[Docket No. 83-ANE-14-AD; Amendment 39-14043; AD 83-08-01R2]

Airworthiness Directives; Hartzell Propeller Inc. (Formerly TRW Hartzell Propeller) Models HC-B3TN-2, HC-B3TN-3, HC-B3TN-5, HC-B4TN-3, HC-B4TN-5, HC-B4MN-5, and HC-B5MP-3 Turbopropellers

ACTION: Final rule.

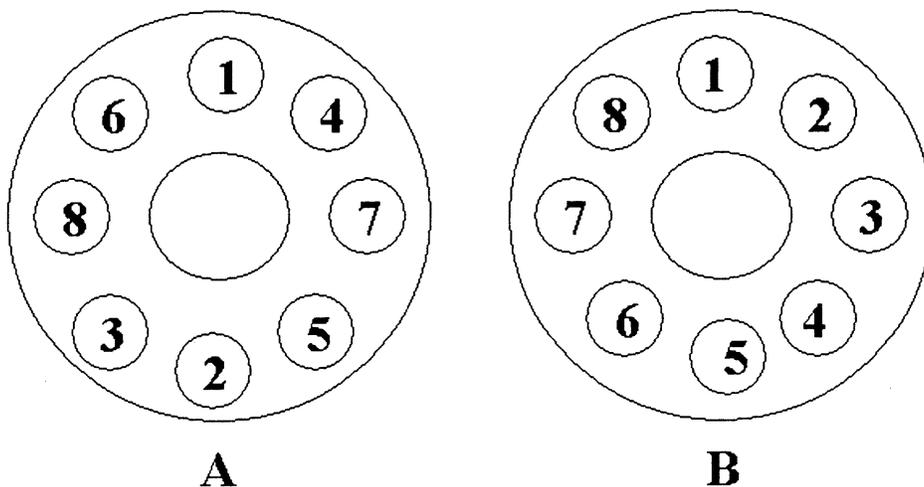
We partially agree. For clarification, we have added references to the use of other equivalent FAA-approved

serviceable bolts and washers, in lieu of using only P/N B-3339 bolts and P/N A-2048-2 washers.

We have corrected the Petrolated Graphite Military Specification number in the compliance section from MIL-T-5544 to MIL-T-83483.

(5) Torque all attaching bolts with a torque wrench and an appropriate adapter, to 40 ft.-lbs., and then to 80 ft.-lbs., following sequence "A" (shown below). Final torque all attaching bolts using sequence "B" (shown below) to 100 ft.-lbs. to 105 ft.-lbs. Safety wire all attaching bolts in an FAA-approved manner.

(3) Apply MIL-T-83483 Petrolated Graphite, or Hartzell Lubricant part number (P/N) A-3338, to threads of the eight P/N B-3339 attaching bolts (and remainder of bolt if desired) and to flat surfaces of the eight P/N A-2048-2 washers, or to other equivalent FAA-approved serviceable bolts and washers.

(4) Install the eight P/N B-3339 attaching bolts and eight P/N A-2048-2 washers, or other equivalent FAA-approved serviceable bolts and washers, that were prepared in paragraph (a)(3) of this AD, through the engine flange and into the propeller flange.
